Plugging Procedure Federal 21 #3 API No. – 30-041-10515 O-21-O7S-33E 660 FSL 1980 FEL

Federal 21 3 30-041-10515 Ridgeway Arizona Oil Corp May 17, 2016 Conditions of Approval

Permanent Abandonment of Federal Wells Conditions of Approval

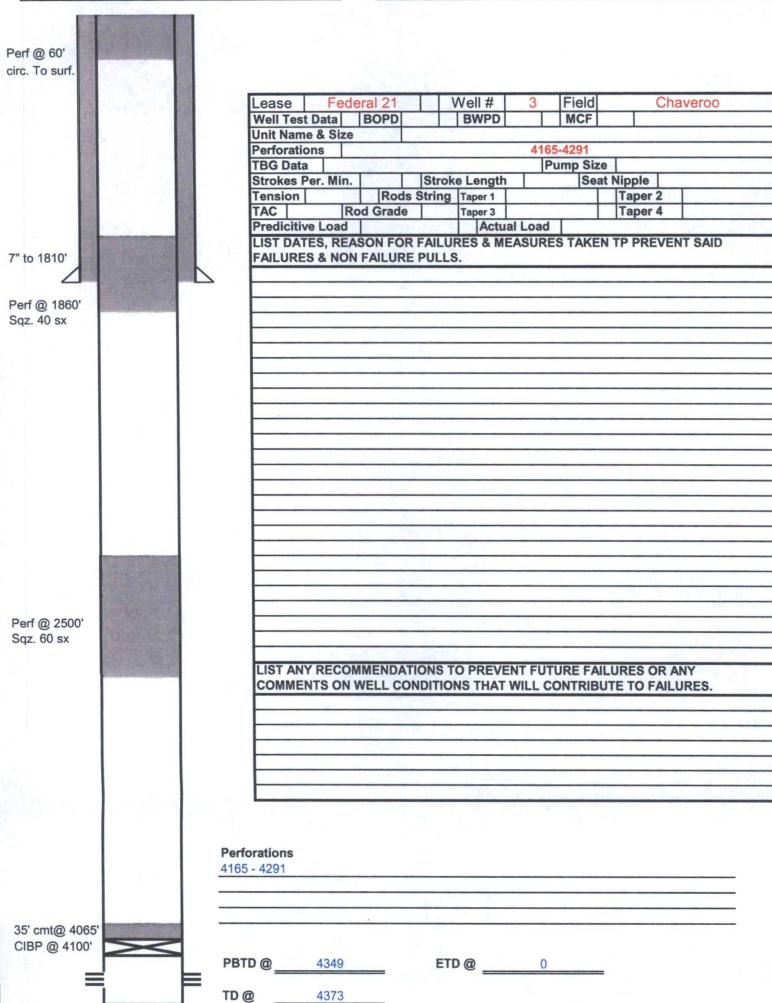
- 1. Operator shall place CIBP at 4,115' (50'-100' above top most perf) and place 35' of Class C cement on top as proposed. WOC and TAG.
- 2. Operator shall perf and squeeze at 2,500'as proposed tagging plug at 2,300'.
- 3. Operator shall place a balanced Class C cement plug from 2,300'-2,175' to seal the top of the Yates formation. WOC and TAG.
- 4. Operator shall perf and squeeze at 1,860' as proposed tagging plug at 1,760' to seal the surface shoe.
- 5. Operator shall place a balanced Class C cement plug from 60'- surface as proposed
- 6. See Attached for general plugging stipulations.
